UNITED STATES PATENT AND TRADEMARK OFFICE

APPLICATION NO.	FILING DATE	FIRST NAMED INVENTOR	ATTORNEY DOCKET NO.	CONFIRMATION NO.
09/964,639	09/28/2001	Dong-Gyu Kim	6192.0186.AA	1991

Office Action Summary

DETAILED ACTION***Claim Rejections - 35 USC § 103***

FIG. 3

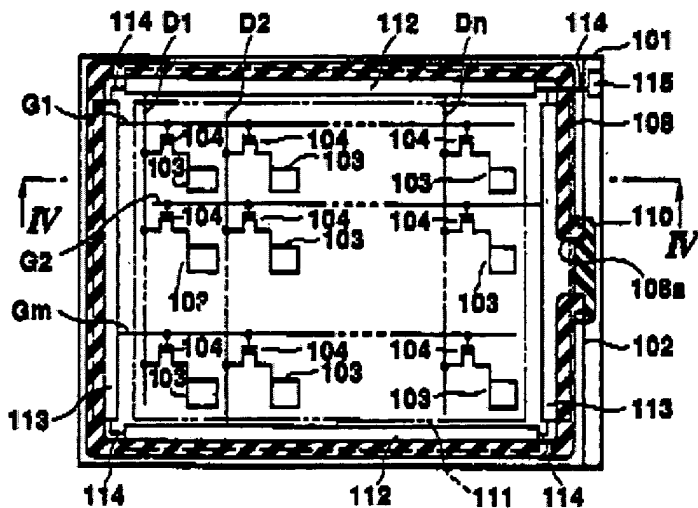
3. Sawatsubashi discloses and shows in Fig. 3, a display device, comprising:

- a first substrate having a plurality of gate lines (G1-Gm) and a plurality of
- data lines (D1- Dn);

- a plurality of thin film transistors (104) electrically connected to the gate lines and the data lines;
- a plurality of pixel electrodes (103) electrically connected to the thin film transistors respectively;
- a plurality of gate driving ICs (113) to output gate signals to the gate lines;
- a plurality of data driving ICs (112) to output data signals to the data lines; and
- a plurality of signal lines (114) (applicant's interconnection lines) apply gate control signals to at least one of the gate driving ICs (145) (col. 5, lines 1-16).

Sawatsbashi differs from the instant invention because he does not explicitly disclose the claimed black matrix overlapping at least one of the interconnection lines.

It is common and known in the art to form black matrix on a substrate opposite to the substrate where the gate lines and the data lines are formed and outside the display area (interconnection lines are typically formed outside the display area) so that it overlaps the interconnection lines in order to prevent light leakage and thus improve display quality.

Therefore, it would have been obvious to one of ordinary skill in the art at the time of the invention was made to modify the display device of Sawatsbashi by forming

a black matrix such that it overlaps the interconnection lines so that light leakage is prevented and display quality is improved.
